BELOW-THE-HOOK LIFTING DEVICE Engineering Note Cover Page

Device Name or Description: MINOS NEAR COIL LIFTING FIXTURE

Engineering Note Prepared by: JIM KILMER, BOB WANDS Date: 3/21/02

Engineering Note Reviewed by: MAREK KRAMARZ Date: 11 APR 02

Changes needed on drawing

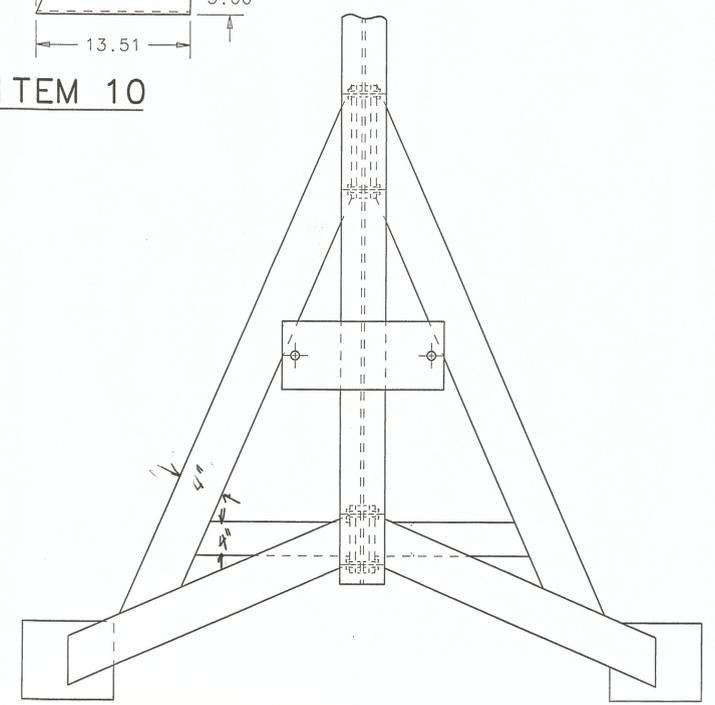
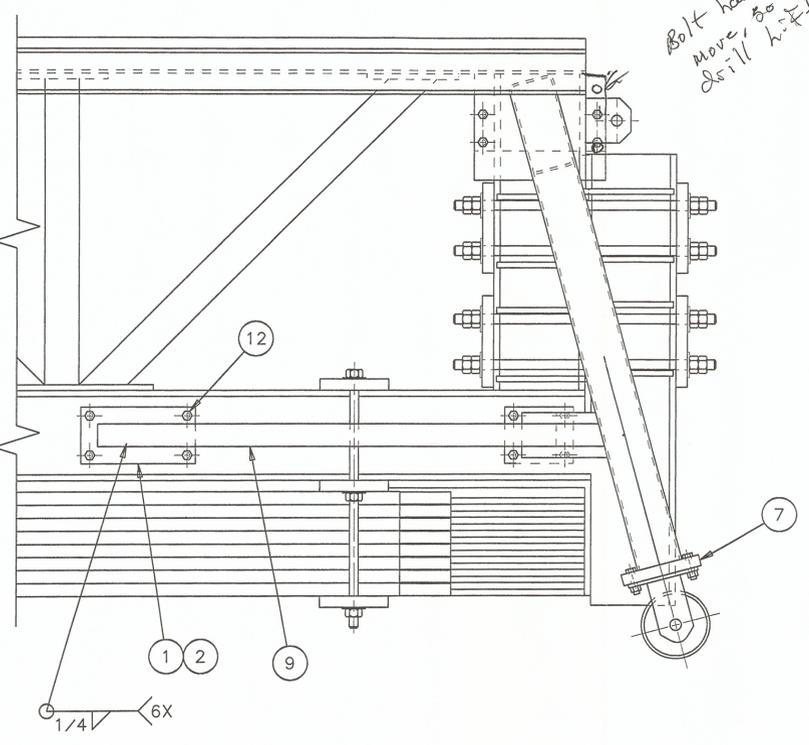
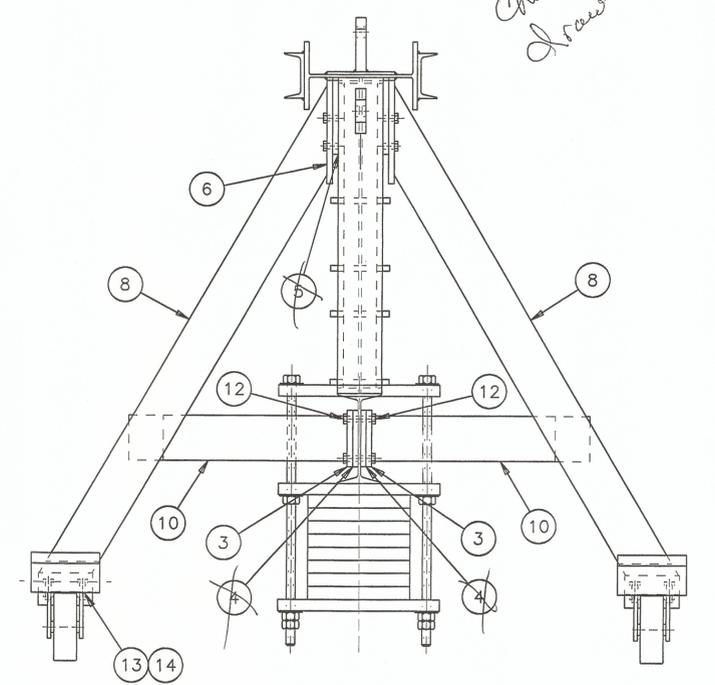
Bolt have been move, so we did not drill hitting deep

is not used
Bolt moved to miss h. 197
